AIRWORTHINESS DIRECTIVE

**AD/RES/20
Amdt 1**

Eon Corporation E6000 Buckle Assemblies

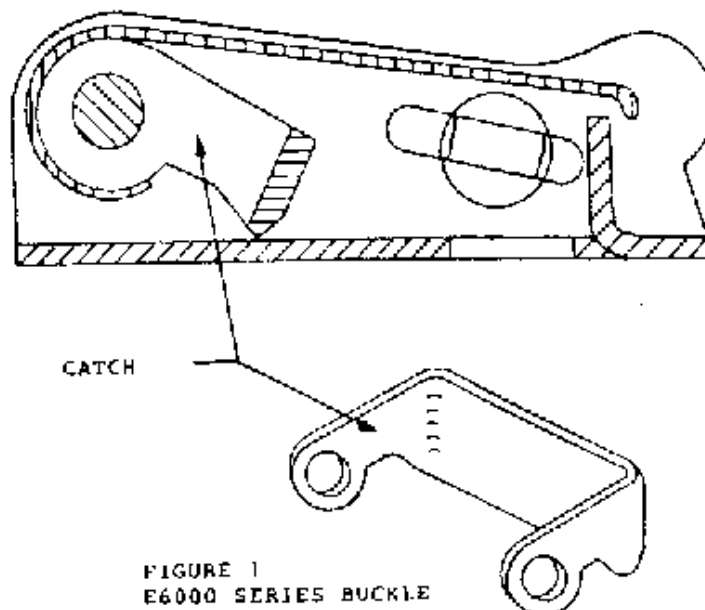
- Requirement:
1. Inspect all seat belts to determine if they are marked as having been manufactured by the EON Corporation under “TSO-C22”. This includes all seat belts supplied under an airframe manufacturer’s part number.
 2. If the seat belt is marked as an EON Corporation seat belt manufactured under “TSO-C22”, determine if an E6000 buckle is fitted. If an E6000 buckle is fitted, remove the seat belt assembly and replace with another item approved in accordance with regulation 21.305 of CASR.
 3. The seat belts removed in compliance with this AD are to be destroyed or have the “TSO-C22” markings removed or totally obliterated.
 4. No E6000 buckle may be installed as a spare part after the effective date.

Note 1: An E6000 buckle assembly has a front cover plate which is pivoted at one end and is pulled at the other end through an arc to release the latch from the buckle. The E6000 buckle assemblies can be identified by the type of catch they use. Figure 1 shows the configuration of the catch and how it is located within the buckle assembly.
